Subject: AP1000 COL Standard Technical Report Submittal of APP-GW-GLN-111, Revision 0

APP-GW-GLN-111, Revision 0

“Component Cooling System and Service Water System Changes Required for Increased Heat Loads,”

## **COMPONENT COOLING SYSTEM AND SERVICE WATER SYSTEM CHANGES REQUIRED FOR INCREASED HEAT LOADS**

Figure 9.2.1-1

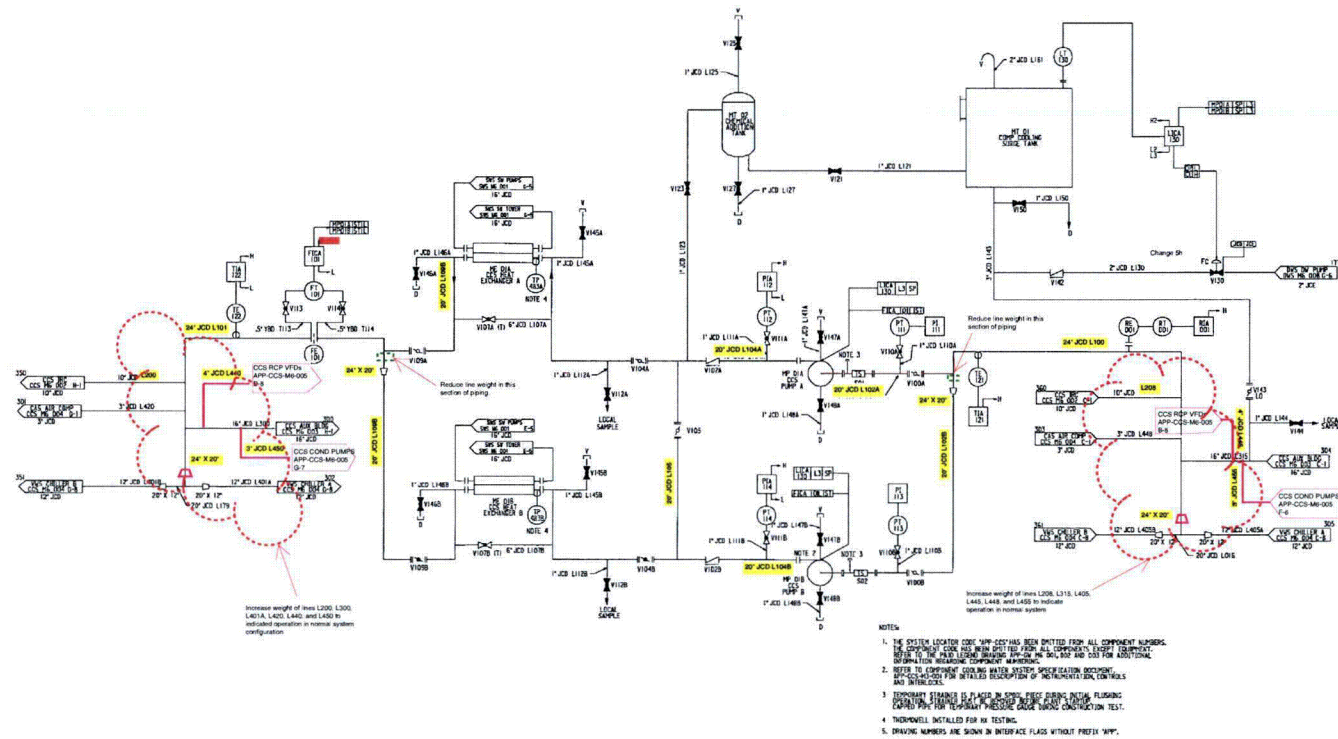
- Table 8.3.1-1 & -2, changes to diesel loads for SWS and CCS components.
- Table 9.1.3-1, change to CCS pressure for SFS HX.
- Section 9.2.2.3.4, change to CCS design pressure.
- Table 9.2.1-1 changes to SWS operating mode conditions.
- Table 9.2.1-2 changes to CCS pump and heat exchanger parameters.
- Table 9.3.6-2, change to design pressure for CVS Letdown HX shell side.
- Table 11.2-2, change to design pressure for WLS RCDT HX shell side.
- Table 16.3-2, change to SWS flow requirement.
- Figure 9.2.1-1, changes to SWS piping diagram.
- Figures 9.2.2-2 (sheets 1 through 5) changes to CCS piping diagrams.
